CITY OF BLOOMINGTON

DEC. 20, 2012 @ 5:30 p.m.
COUNCIL CHAMBERS #115
CITY HALL

BLOOMINGTON BOARD OF ZONING APPEALS
LOCATION: 217 W. Kirkwood Avenue

CASE #: V-46-12
DATE: December 20, 2012

V-46-12
Site Plan

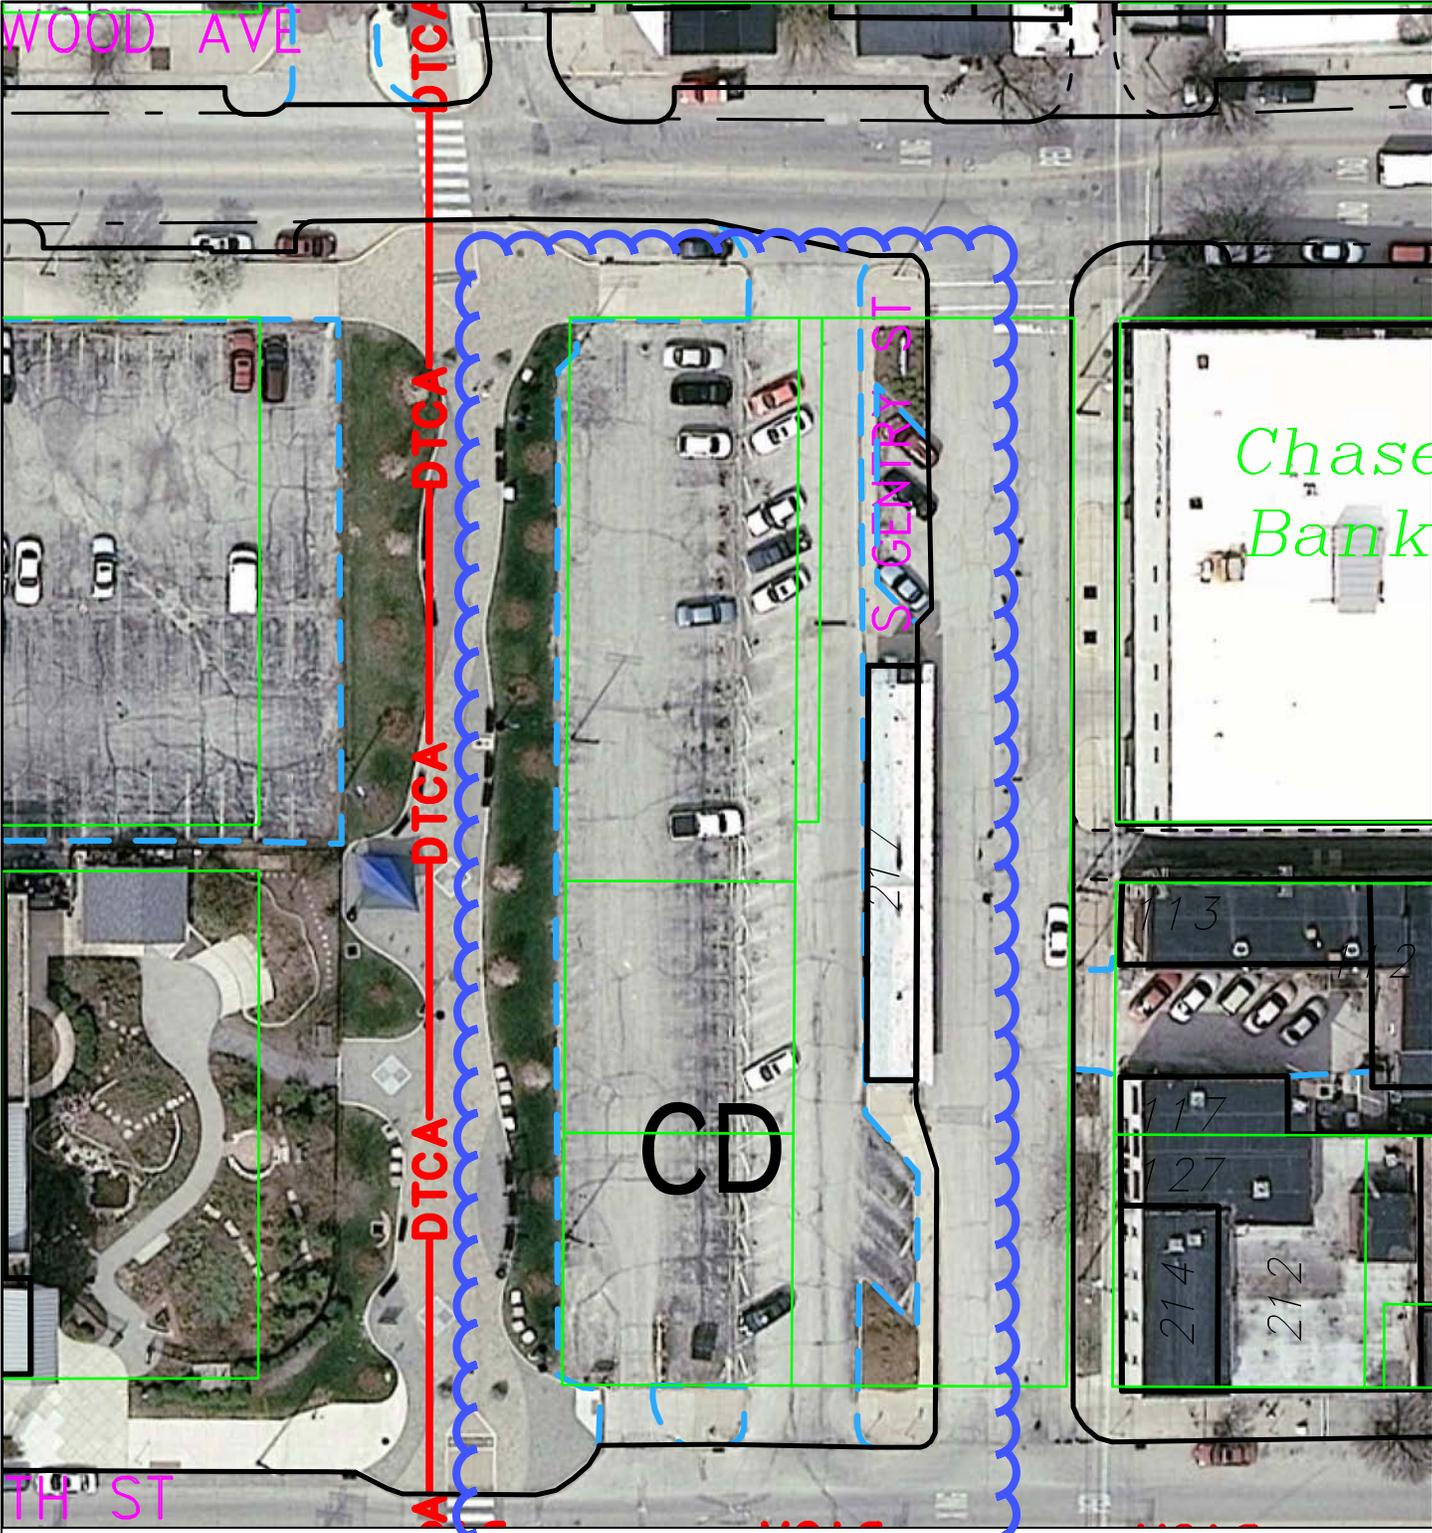
Sidewalk: With the site plan approval, staff analyzed the possibility of placing sidewalk along the west side of Gentry Street as is required by the Unified Development Ordinance (UDO). Staff finds that the inclusion of such a sidewalk is not advisable due to a lack of adequate right-of-way and the desire to allow for two one-way lanes of traffic. The existing street has between 35 and 41 feet in pavement width. However, the right-of-way is only 20 feet in width. So although there appears to be plenty of room for a sidewalk, the street will be reduced to approximately half of its existing width.

Driveway: With this proposal, several drive cuts will be removed including cuts onto both 4th St. and Kirkwood Ave. The petitioner has worked with staff to design the site with only one drive cut that would be placed on the southern portion of Gentry St. Gentry St. requires a 100-foot minimum setback for a drive from its intersection with 4th St. As proposed, the drive cut is approximately 55 feet from this intersection. Staff finds this location to be the most functional. The drive is accessing an internal ramp that serves the structured parking for the hotel. With the internal parking decks, the ramp must be located near one end of the building. Staff and the Plan Commission found it appropriate for this ramp to be located closer to 4th Street than Kirkwood Ave. This variance is further justified by the fact that traffic on Gentry St. is one-way to the south. Therefore, its proximity to 4th St. will not create any back-up potential for traffic associated with the hotel garage.

Signage: The CD district limits the total signage for any tenant to a maximum of 100 square feet. Usually a building of this size would have multiple tenants or be utilized for multi-family. Individual tenants are allowed up to 1.5 square feet of signage for every foot of tenant façade. The three public street frontages would usually allow for up to approximately 800 square feet. Blade signs, although allowed in the Commercial Downtown zoning district, are not permitted within the Courthouse Square Overlay (CSO). The number of blade signs is also limited to a single sign per tenant, per street frontage. This is a very unusual property in that it is a very large individual user that has three public street frontages. The property, although within the CSO, is not located immediately adjacent to the square. Staff and the Plan Commission have worked with the petitioner to develop an appropriate sign package for this property. This sign package would modify the petitioner's original proposal. The petitioner is aware and in agreement with these changes. The new package includes the following signage:

Sidewalk: Staff finds practical difficulty in requiring a sidewalk on the west side of Gentry St. This street does not go through to either the north or south and functions much as an alley. Furthermore, it will be a one-way street. By requiring the sidewalk to be installed, the limited right-of-way would create a pavement width of 15 feet which would not allow for pull-off traffic of the hotel. The site was designed to have drop off removed from Kirkwood Ave. and 4th St. and utilize the lower usage Gentry St. Staff finds peculiar condition in the narrow right-of-way for Gentry St. (20 feet plus a 12-foot alley right-of-way). This is much less than the 50 feet that is normally required. Therefore there is not enough room to fit the usual facilities including sidewalks without removing the ability of the street to function properly. The existing sidewalk on the east side and the B-Line Trail provide for adequate alternative pedestrian traffic.

Driveway: Staff finds hardship in requiring the drive to be relocated further to the north. Due to the one-way nature of Gentry St, this shift would create a difficulty in accessing the internal parking in a reasonable manner without creating layout problems on the interior of the hotel with little improvement to the safe flow of traffic. Practical difficulty is found in the difficulty of designing a hotel with three public street frontages and a large urban trail. Access has been highly limited and located on the lowest profile street.

Signage: Staff finds the UDO signage requirements would not provide a sign package that would adequately identify the hotel and the parking location. Due to the size of the property and the proposed building, a multi-tenant structure would be permitted a much larger amount of signage. The placement of the signage at the top of a 7-story building will also reduce the visual impact of the proposed signage.

RECOMMENDATION: Based upon the written findings above, staff recommends approval of V-46-12 with the following conditions:

1. All blade signs shall not exceed 20 square feet in sign area.
2. The proposed blade signs on the Kirkwood façade located at the northwest corner of the building and the blade sign located on the Gentry façade near the SE corner of the building shall not be permitted.
3. No other signage is approved without a new signage variance or compliance with current sign standards.

SITE PLAN

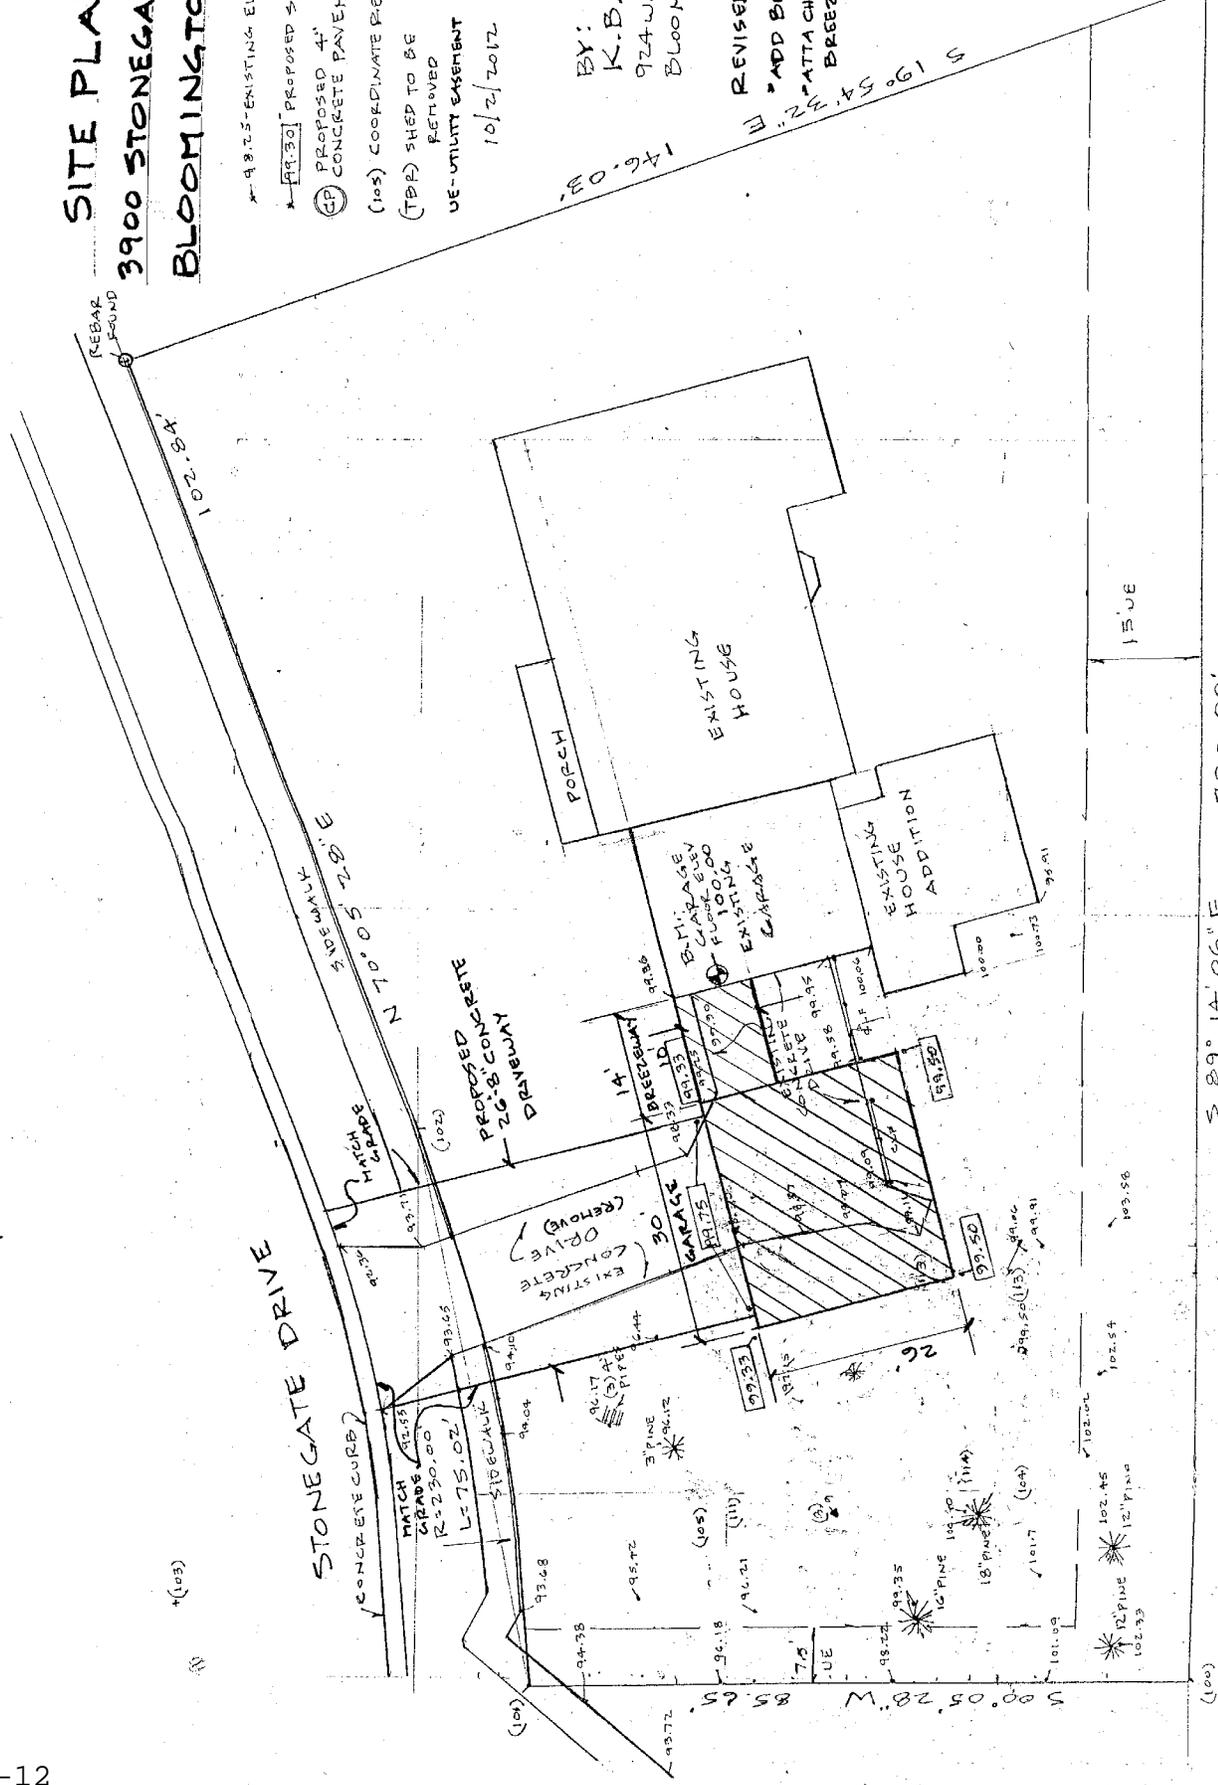
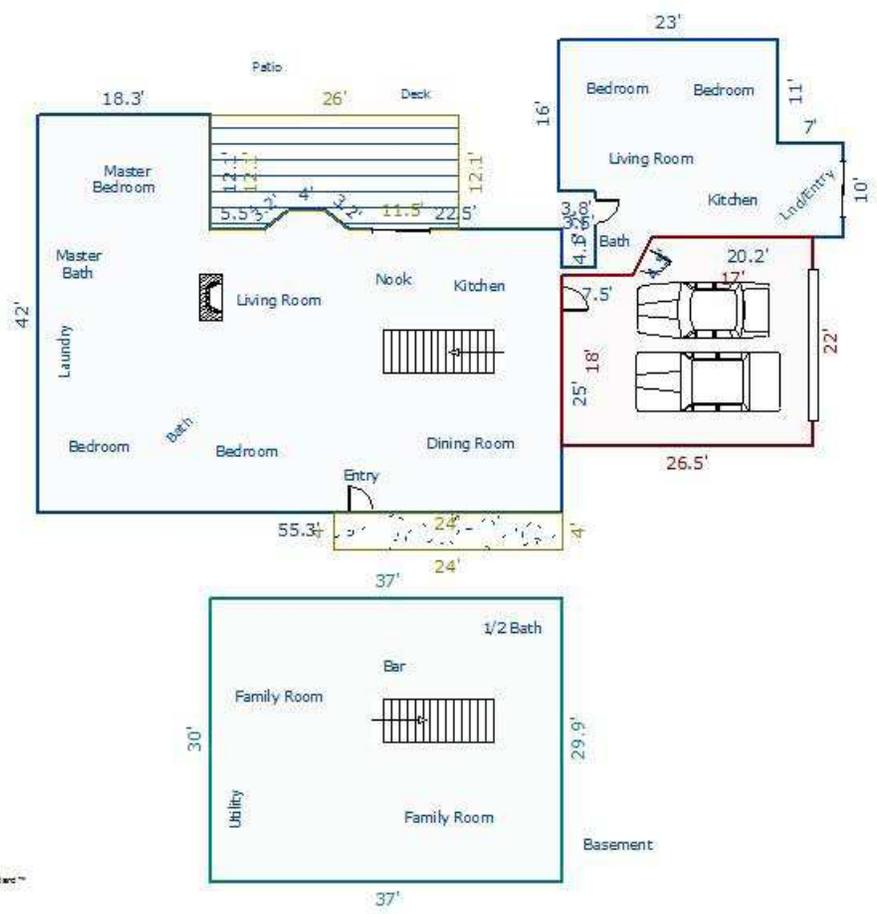
In 2006, the property owner applied for a building permit for an addition to the house. The property owner's intent was for the building addition to serve as a dwelling unit for her mother and sister. A Certificate of Zoning Compliance was issued with a condition that "No increase in number of dwelling units is approved." However, that condition was not noticed by the property owner, and the addition has been used as an additional dwelling unit since 2006. The property owner is proposing to expand the second dwelling unit into the existing attached garage. The expansion would include a living room and an expansion to the bathroom to provide a walk-in tub. Additionally, a new attached garage and breezeway are proposed.

The Stonegate PUD allows single family houses but does not allow duplexes. The petitioner is requesting a use variance to permit a two-family dwelling and has agreed to a deed commitment limiting the occupancy of the second unit to family of the occupants of the first unit.

RECOMMENDATION: Based upon the written findings above, staff recommends approval of UV-48-12 with the following condition:

1. A commitment shall be recorded on the deed which requires occupancy of both units to be limited to family only, consisting of an individual or a group of people all of whom are related to each other by blood, marriage, or legal adoption, and any other dependent children of the household

V-57-12
Site Plan

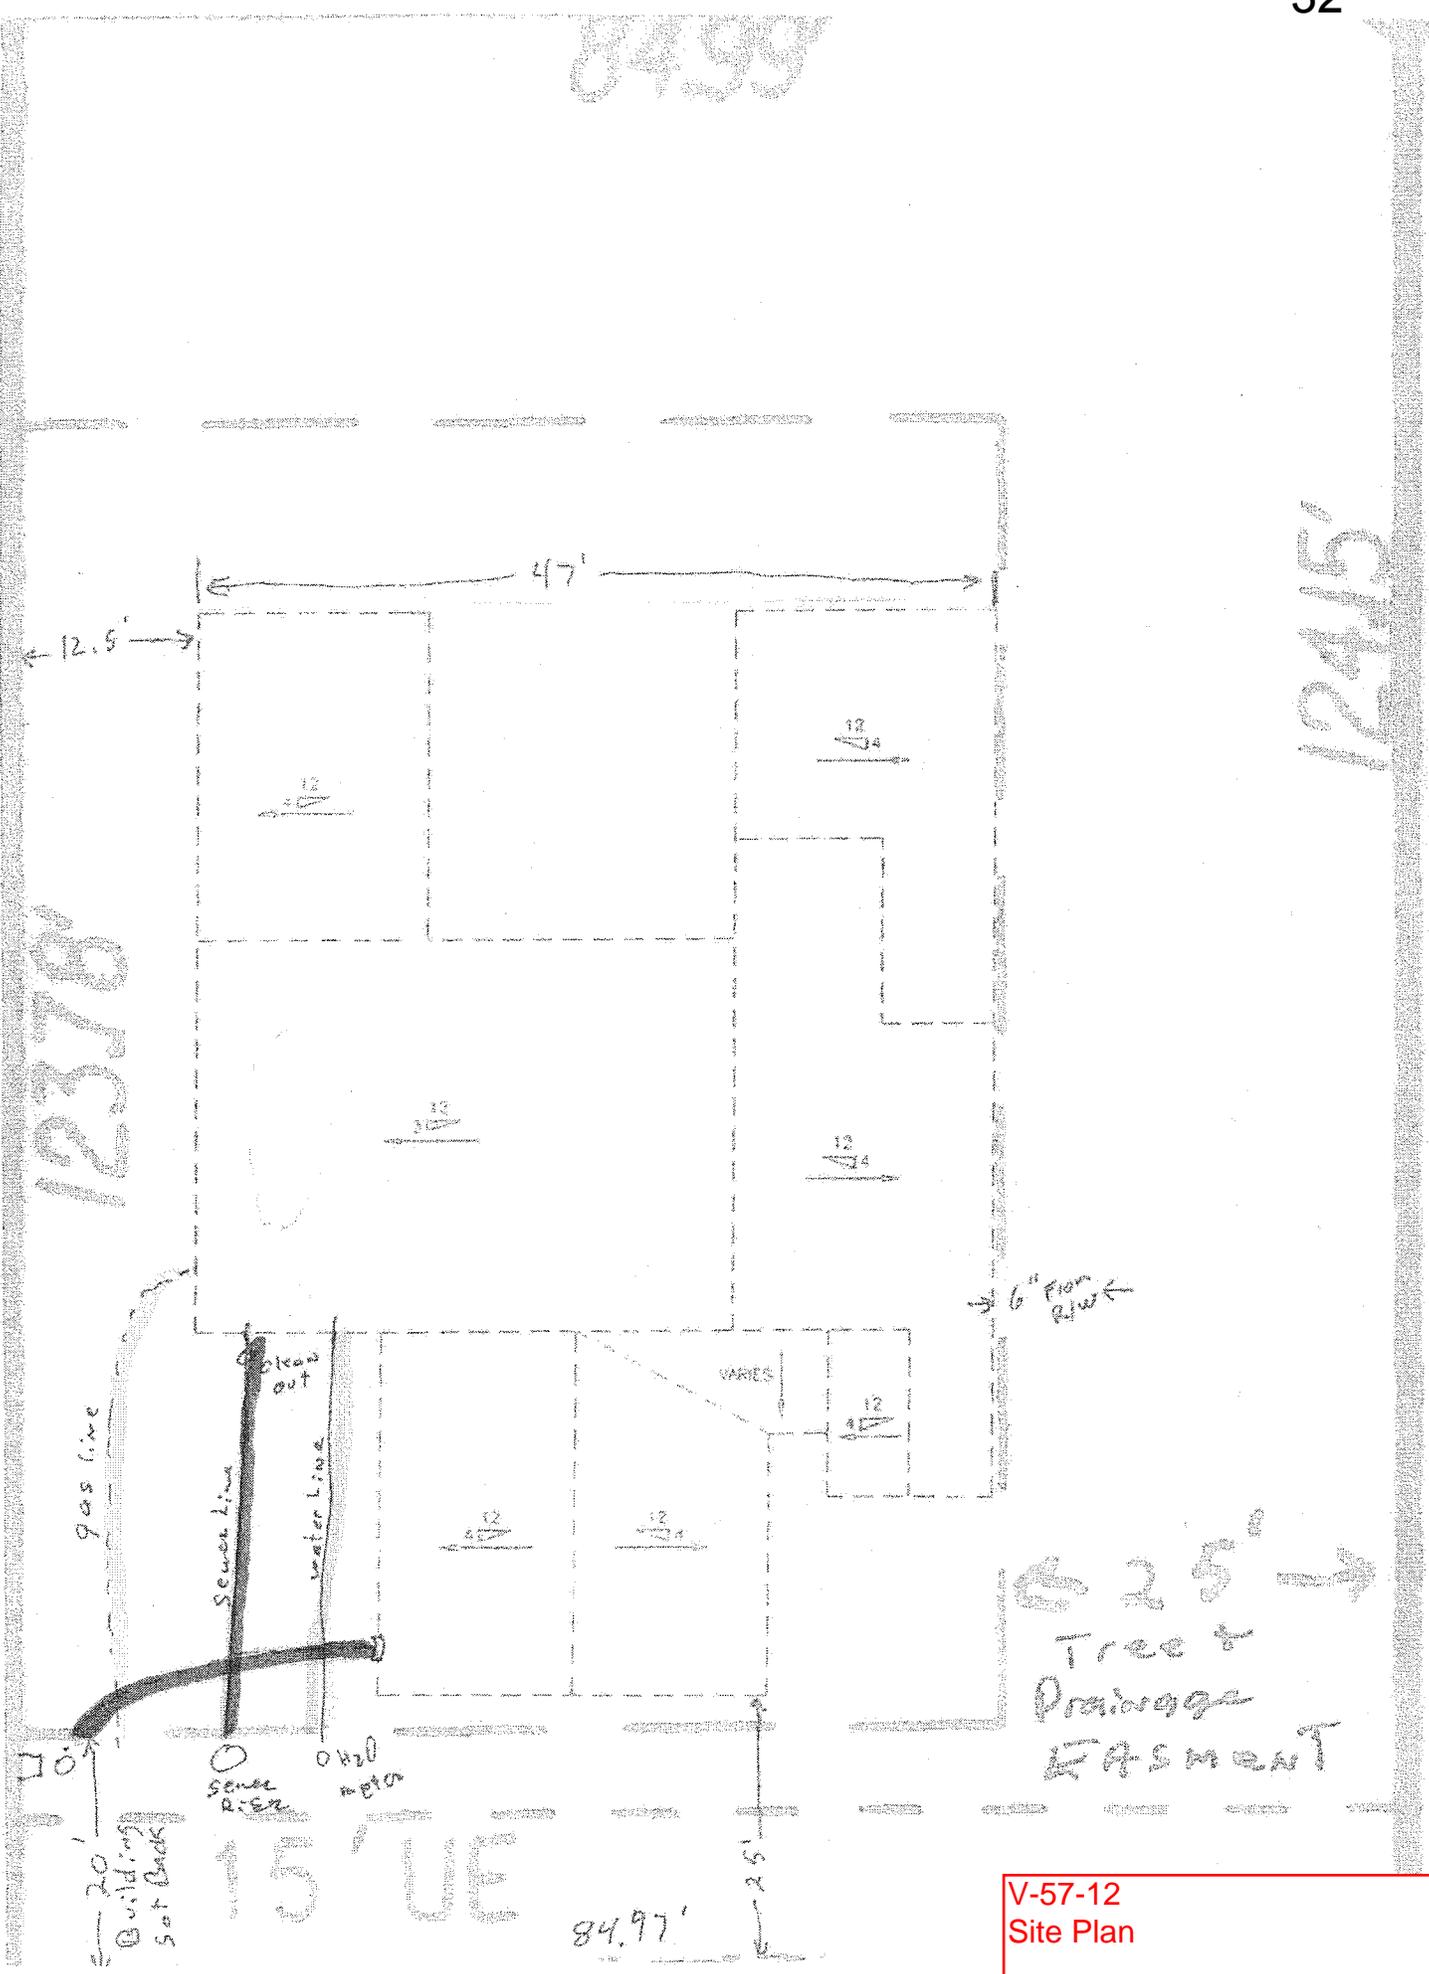
The petitioner received a building permit on October 5, 2012 to construct a new single family residence on the property. The submitted site plan met all setback requirements. During the initial lot layout, the contractor measured the front setback for the footers and walls from the edge of curb and not the actual property line. As a result, the new residence is located 13.5' from the front property line rather than the required 20'. The residence also encroaches 1.5' into a 15' utility easement that runs along the front of the lot.

Staff has worked with the petitioner to alter the site layout and floor plan to address parking issues and improve the house aesthetics. The petitioner has agreed to change the garage design from a front loaded garage to a side loaded garage. This change allows cars to park on the driveway without encroaching into the street right-of-way or sidewalk and improves the look of the garage that is located closer to the street. In addition, the petitioner has agreed to add windows along the west side of the garage facing the street to improve the view from the public right-of-way.

Parking: The petitioner has agreed to revise the layout of the driveway and garage layout to change the garage to a side loaded garage which allows for the driveway to come in from the north and provides parking area on the property adjacent to the garage. This reduces the possibility that cars parked on the driveway would encroach in the right-of-way or impede the sidewalk.

Utilities: The residence does encroach 1.5' into a Utility Easement that runs along the front of this property. Since this is at the end of the street there are no public utilities

RECOMMENDATION: Based upon the written findings above, staff recommends approval of the variance request with the following conditions:

1. This variance applies only to the existing structure under construction. Any future construction or addition must meet the 20' setback requirement.
2. The garage must be modified to a side loaded garage with at least 3 windows installed along the west elevation.
3. This approval is contingent upon subsequent approval of a revised utility easement on the plat for this lot.
